Access Compliance Report

Public Rights-of-Way

(Curb Ramps)

Intersection ID: 50203	Main Street: WEDDINGTON_RD	Cross Street: COLTSVIEW_LN	Location: SW
ADA ID: F4557D43F71D	Ramp Type: BlendTrans1	Initial Pass/Fail: Fail	Overall Compliance: No
Severity Score: 8.75			
Codes/Mitigation Info/Possible Solution		Field Measurements/Component Compliance

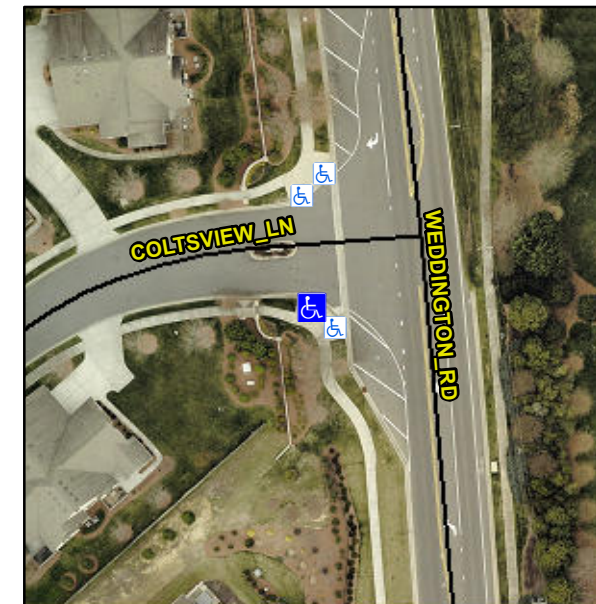
Not Found, R304.5.1

Compliance	Description	Data	Compliance	Description	Data
N/A	Ramp Length (in)	97.0	Yes	BlendTrans Slope (%)	4.7
No	Ramp Width (in)	47.5	Yes	BlendTrans XSlope (%)	1.5
N/A	Flare Type LT	N/A	N/A	Flare Type RT	N/A
N/A	Flare Slope LT (%)	N/A	N/A	Flare Slope RT (%)	N/A
N/A	Flare Traversable LT?	N/A	N/A	Flare Traversable RT?	N/A
N/A	Landing Length (in)	N/A	N/A	DWS Provided?	N/A
N/A	Landing Width (in)	N/A	N/A	DWS Contrast?	N/A
N/A	Landing Slope (%)	N/A	N/A	DWS Length (in)	N/A
N/A	Landing X Slope (%)	N/A	N/A	DWS Full Width?	N/A
N/A	Landing Curb? (Y/N)	N/A	N/A	DWS Offset (in)	N/A
N/A	Shared Landing?	N/A			
N/A	Gutter Ponding?	N/A	N/A	Gutter Slope (%)	N/A
N/A	Gutter Lip Ht (in)	N/A	N/A	Gutter X Slope (%)	N/A
N/A	Painted X Walk1?	No	N/A	Painted X Walk2?	N/A
	X Walk 1 Direction	To N		X Walk 2 Direction	N/A
	X Walk 1 Width (in)	N/A		X Walk 2 Width (in)	N/A
	X Walk 1 Slope (%)	1.9		X Walk 2 Slope (%)	N/A
	X Walk 1 X Slope (%)	3.4		X Walk 2 X Slope (%)	N/A

N/A	Ramp inside XWalk1?	N/A	N/A	Ramp inside XWalk2?	N/A
	Road Slope (%)	3.4		Clear Space?	N/A
	Road X Slope (%)	1.9	N/A	Clear Space to XWalk (in)	N/A
N/A	Any Obstructions?	N/A	N/A	Storm Grate/Utility Hazard?	N/A
	Obstruction Type			Storm Grate/Utility Type	
		N/A			N/A
			Yes	Surface Condition? (G/P)	Good
			No	Curb Slope (%)	10.1

Remove & Replace Curb Ramp With Two New Directional Ramps or Equivalent.
